MEMORANDUM

FILE NO.: USE2003-00010 - Allowable Use

PROPOSAL: An allowable use permit to construct two 8-plex apartment buildings to be managed by Juneau Alliance for Mental Health Inc. (JAMHI).

ATTACHMENT A

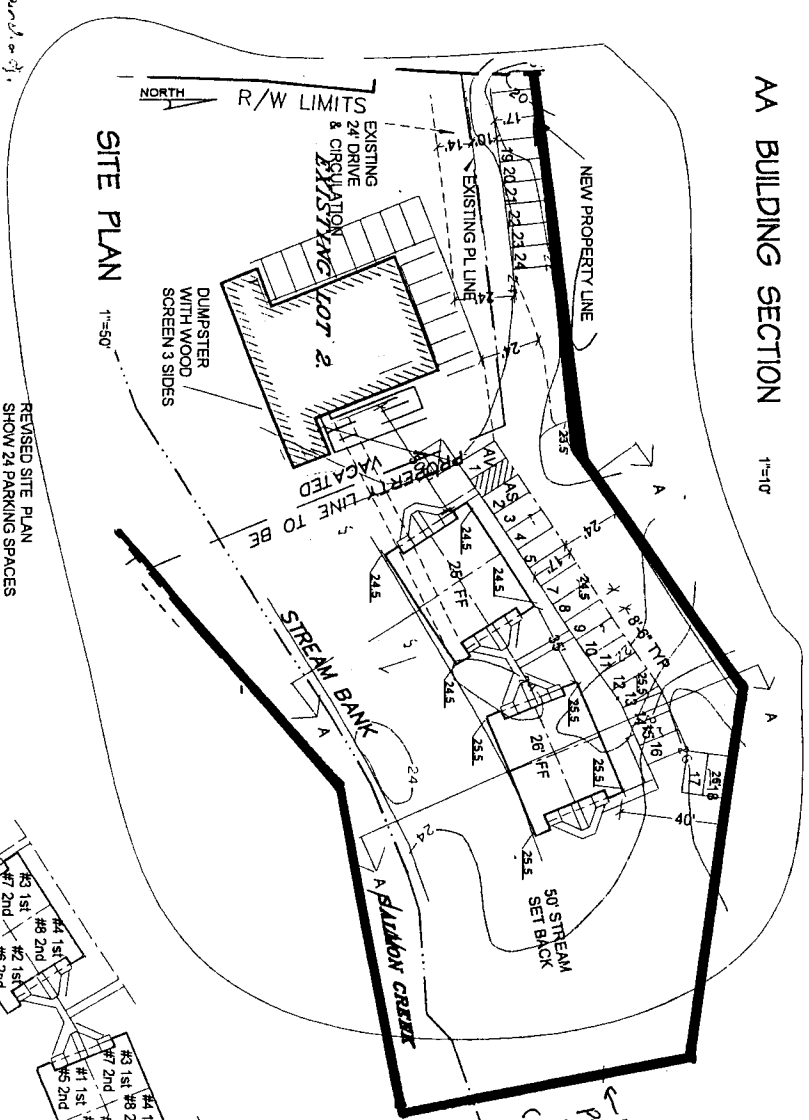
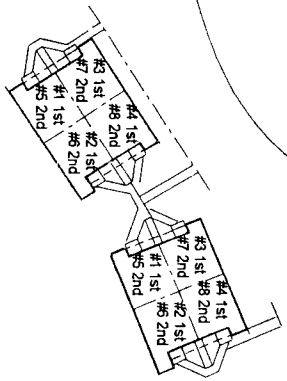
The applicant has submitted a parking plan which provides the number of spaces required (see Attachment A). The layout of the parking lot as shown is based on a pending boundary line adjustment to consolidate the existing JAMHI parcel to the west with a portion of the parcel to be developed with the proposed 8-plexes. A shared driveway with the existing JAMHI lot provides the required isle width of 24 feet for two-way circulation. The parking plan enclosed will be acceptable only with the completion of the boundary line adjustment. If the boundary line adjustment is not obtained, the applicant will be required to move the parking spaces adjacent to the access isle to another area of the lot (most likely to the eastern side of the farthest 8-plex structure). Staff has discussed this scenario with the applicant who has agreed to make modifications if the boundary line adjustment is not completed. Staff is recommending a condition to ensure the parking lot layout is consistent with this agreement before issuance of a building permit.

- 2) The parking plan, dated April 10, 2003, showing a shared access isle from Glacier Highway is acceptable only with the completion of a boundary line adjustment that would vacate the existing property line bisecting the property and move it to surround all of JAMHI's structures. Until the boundary line adjustment is obtained, the applicant is required to move the 6 parking spaces located nearest Glacier Highway to the eastern side of the 8-plex structures and obtain a combined access agreement to use the existing entrance onto the property from Glacier Highway, before issuance of a building permit.

REVISED SITE PLAN
 SHOW 24 PARKING SPACES
 AND 24 BACKOUT PARKING

A2
 of 11
 Attached A

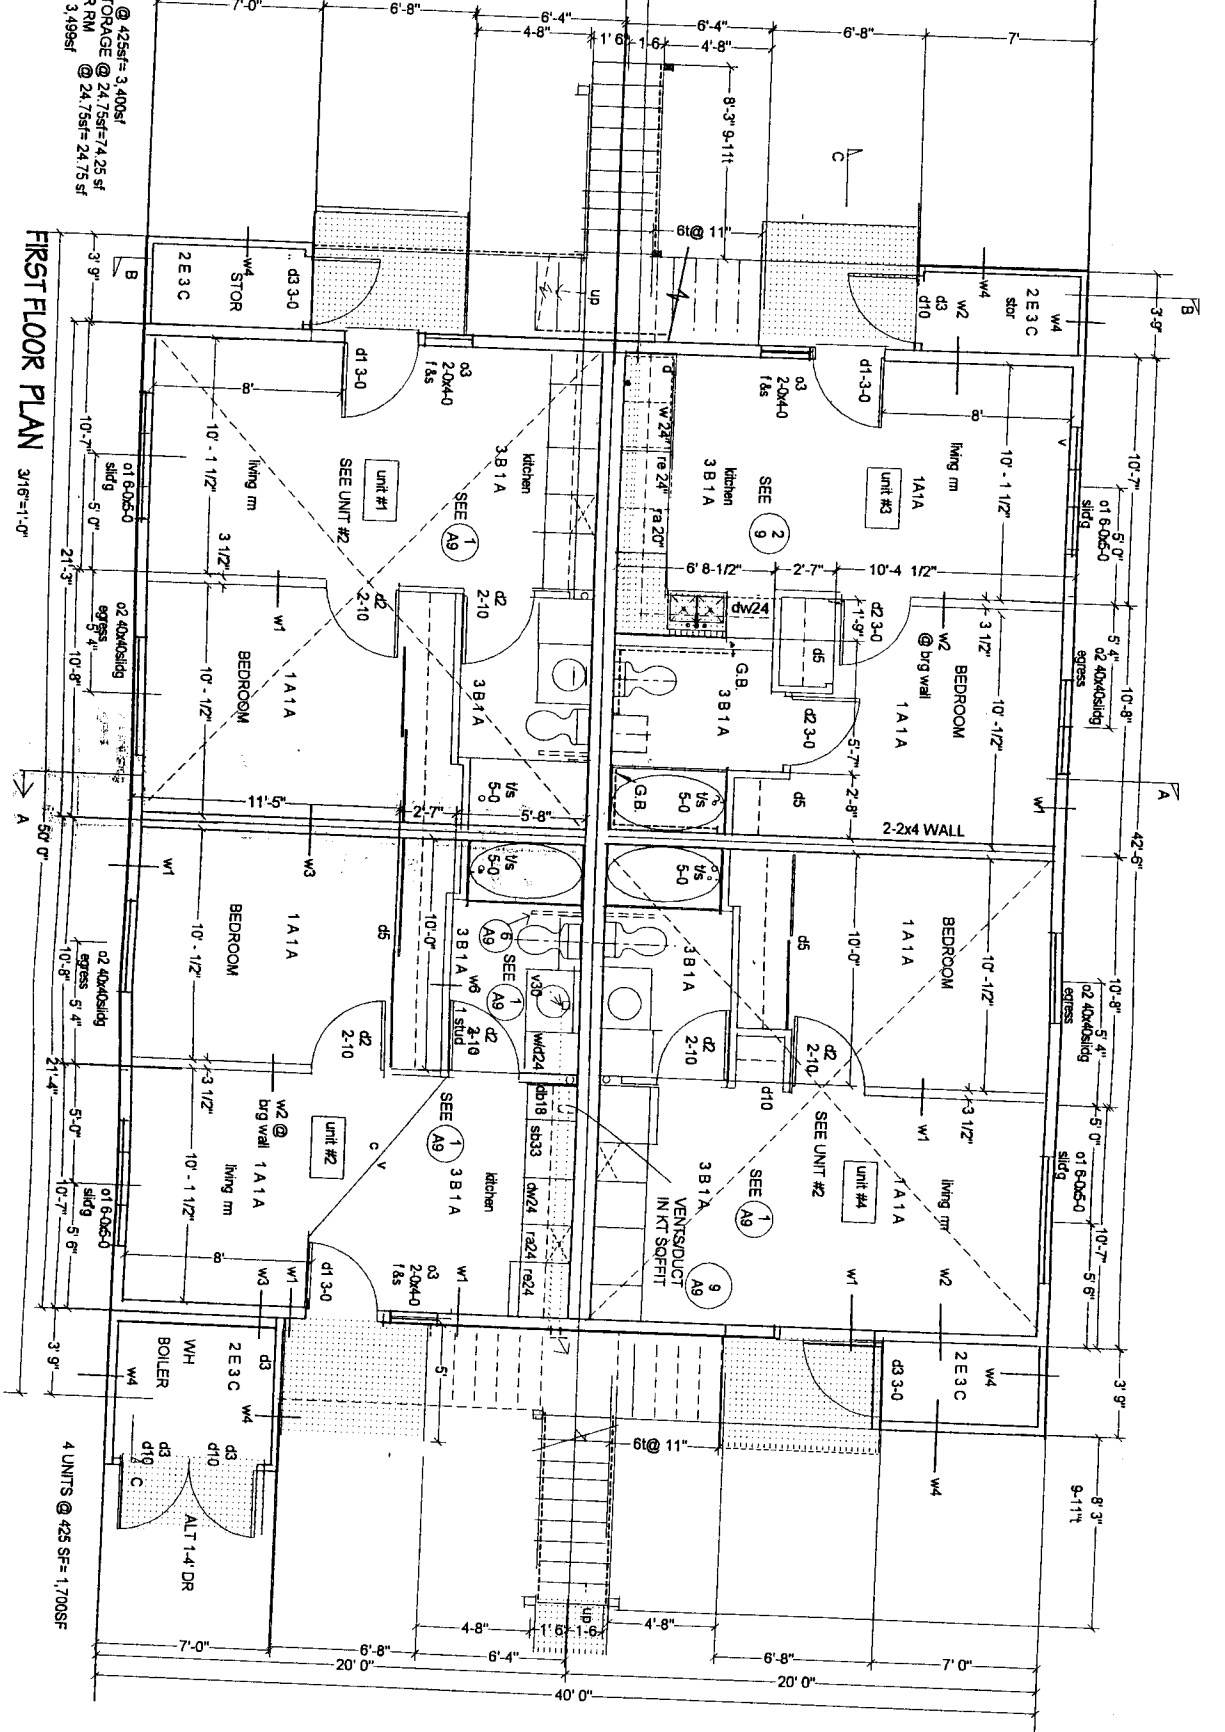
Project Design – Each building consists of 8 one-bedroom apartments of approximately 450 square feet, including living, kitchen, bedroom and bathroom space (Attachment B), with four units on each floor. Total building size is 4,000 square feet, including maintenance, storage and stairwell areas. Each apartment will have an exterior entrance. The two story structures will have cedar trim with mansard shingles and pitched roofs.
